NRC 2001-048

DOCKETS 50-266 AND 50-301
SUPPLEMENT 14 TO APPLICATION FOR AMENDMENT TO
FACILITY OPERATING LICENSE APPENDIX A:
TECHNICAL SPECIFICATIONS IMPROVEMENT PROJECT
RESPONSE TO REQUEST FOR ADDITIONAL INFORMATION ON SPECIFICATION 5.6.5.b
POINT BEACH NUCLEAR PLANT, UNITS 1 AND 2

DOCKETS 50-266 AND 50-301
RESPONSE TO REQUEST FOR ADDITIONAL INFORMATION
TECHNICAL SPECIFICATIONS IMPROVEMENT PROJECT
FOLLOWUP STAFF QUESTIONS
POINT BEACH NUCLEAR PLANT UNITS 1 AND 2

Insert 5.6-2:

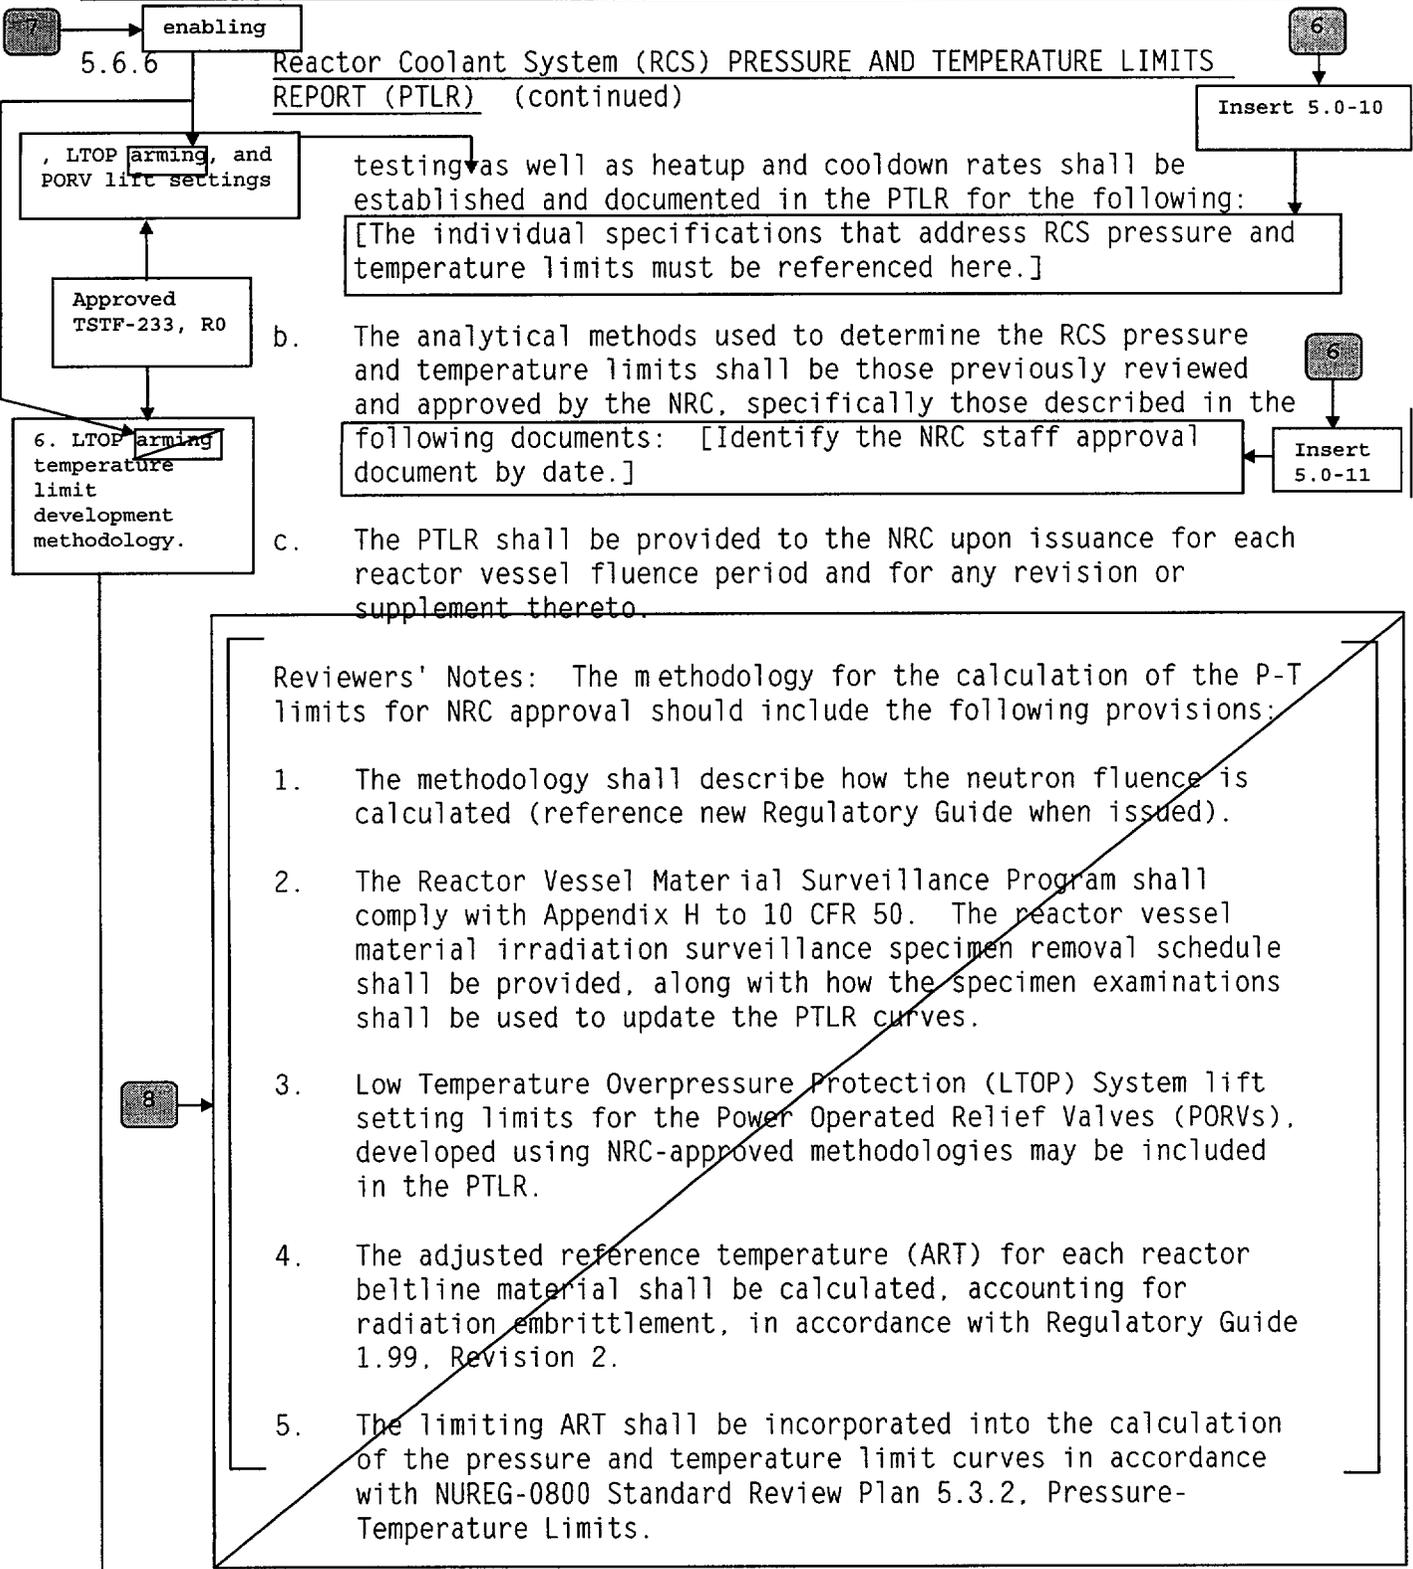
Proposed ITS Specification 5.6.5.b does not currently include reference to the NRC's approval of the analytical methods used by Point Beach to determine the RCS pressure and temperature limits. Comment: Provide a reference in ITS Specification 5.6.5.b to NRC Letter dated July 23, 2001, which documents approval of the analytical methods used by Point Beach to determine the RCS pressure and temperature limits.

The NRC documented approval of the analytical methods used by Point Beach to determine the pressure and temperature limits in a letter dated July, 23, 2001. This reference has been included in the proposed ITS Specification 5.6.5.b. This change also results in a change to the marked up CTS (page 15 of 16) and marked up NUREG Insert 5.0-11. The associated Description of Change, Justification for Deviation and No Significant Hazards Considerations still bound the above changes and do not require revision.

- b. The analytical methods used to determine the RCS pressure and temperature limits shall be those previously reviewed and approved by the NRC, specifically those described in the NRC Letters dated October 6, 2000 and July 23, 2001.
